# FINAL ENVIRONMENTAL IMPACT REPORT (FEIR) VILLAGE AT PLAYA VISTA

## VOLUME II

2004

Revised Draft EIR Figure 93,  
Proposed Project Parks and Open Space

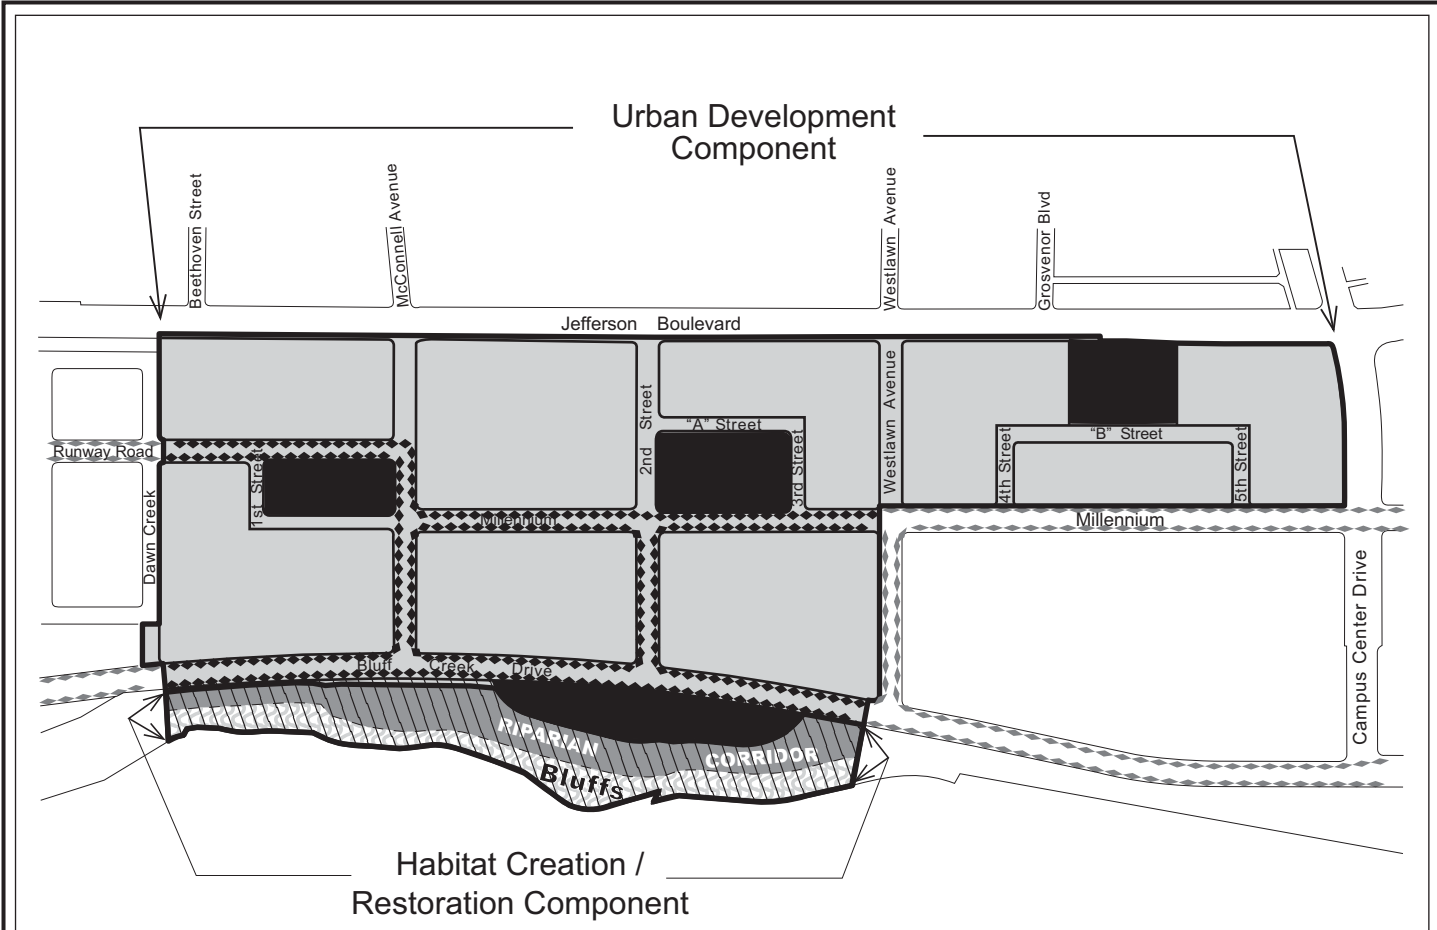
The illustrated parkland distribution of active open space consists of six smaller disjointed park sites (ranging from 1.3-3.5 acres). Although active uses may be developed on each site, they may not fulfill the recreational needs of the community. The Department's Community Recreation Needs Report (1999) has indicated that the community residents in this area seek facilities that include recreation centers (gymnasiums and meeting rooms), sports fields and courts (e.g., ball fields, soccer fields, basketball courts), and aquatic facilities. These facilities allow the Department to offer community-desired programs that include team sports; exercise, dance, and craft classes; aquatic; and after school and seasonal programs. These facilities require sufficient space for buildings, sports fields, and parking. The spaces allotted in the Project may not be large enough to offer the types of facilities and programs needed and desired by the community. The spaces could be grouped to form a single contiguous site and/or a site that is large enough for the types of active recreational facilities needed.

It is our understanding that basketball/tennis courts and sports fields are provided in Phase I. Therefore potential facilities on parkland, indicated on the Proposed Project Open Space map (Figure 93, page 1032), could be developed for other needed recreation uses such as a universally accessible play area, splash pad, and indoor gymnasium.

In Response to the request to combine the six smaller parks into larger parks, the Applicant has combined the parks into four larger parks as reflected on the attached Proposed Project Open Space shown in Revised Draft EIR Revised Draft EIR Figure 93 on page 533. This aggregation will be large enough to offer more active recreation activities than previously would have been permitted by the previous plan, including those of the type referenced by the commentor.

As stated in Response 3-2 above, residents of the Proposed Project will have access to all of the parks and recreation facilities at Playa Vista, including those under construction within the adjacent First Phase Project.
